Notice of Intent

Sundry ID: 2870062

Type of Action: APD Change

Variance Request for Offline Production Cementing

Process and Equipment

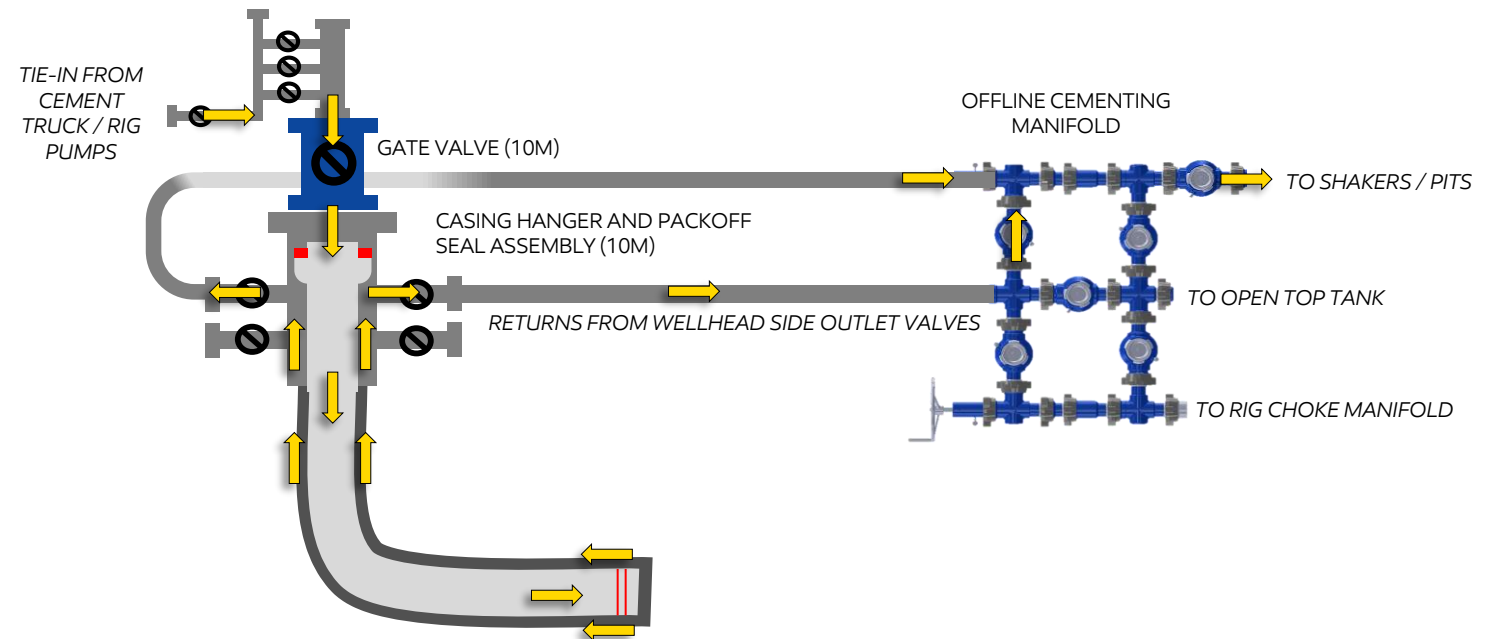
1. Rig BOP replaced by gate valve and WH adaptor assembly (10M rated)
2. Addition of offline cementing manifold and high pressure iron to direct fluid returns to rig active system and/or choke manifold
3. Packoff annulus barrier in place and tested prior to cementing operations (10M rated)
4. Cement truck performs cement job displacement (vs rig pumps)
